CITY PLANNING COMMISSION

C. Plan Review for 10 single story and four townhouse dwelling units to be known as the Broadway Courtyards

LOCATION: 2930 58th Street

**EXHIBIT A
SITE PLAN**

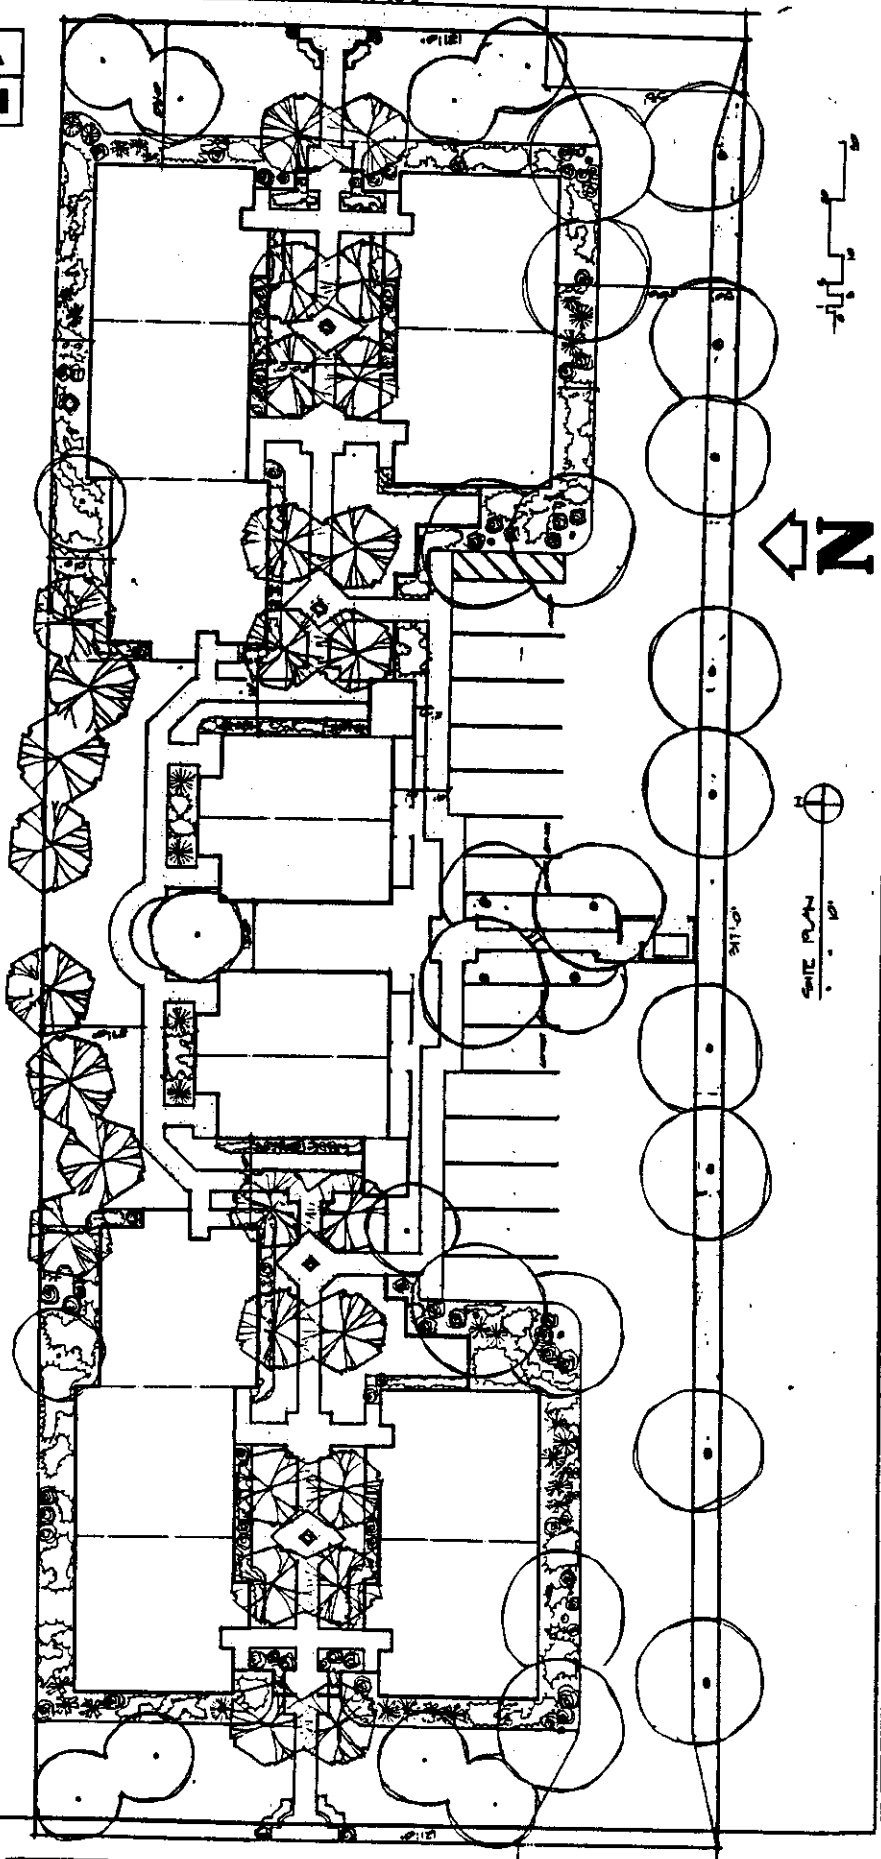
The project is designed with a 25 foot landscape setback along both street frontages. Landscaped courtyards in the interior of the structure are also provided. Parking is adjacent to the commercial sites and will not disturb the existing residential uses to the north. The parking area is also split into two lots by the trash enclosure facility. Staff approves of this division as it will prevent the driveway from becoming a shortcut between 57th and 58th Streets.

Staff approves of the proposed site plan design. Minor modifications will need to be made to the plan to meet the minimum dimensions for compact parking stalls. Staff also recommends that all the parking spaces be covered in order to protect tenant's automobiles from the elements and encourage off-street parking.

The Traffic Engineering Division has reviewed the submitted site plan and requires that the two driveway entrances be reduced in size to a maximum of 24 feet wide. Finally, staff recommends that a solid wood fence be constructed along the north and south property lines in order to insure privacy to both the single family uses to the north and the future tenants of the Broadway Courtyards.

2. A solid decorative wood fence shall be provided along the north and south property lines, subject to Planning Director review and approval. The fence need not be provided in the 25 foot setback areas. A solid masonry wall may be substituted for the wood fence, subject to Planning Director review and approval.

4. The site plan shall be revised to meet minimum parking stall dimensions and the driveway entrance requirements of the City Traffic Engineering Division.

7. Fourteen (14) covered parking spaces shall be provided. Carport materials shall consist of wood trim and shall be compatible in design, materials and color with the residential units. The carports are subject to Planning Director review and approval prior to issuance of building permits.
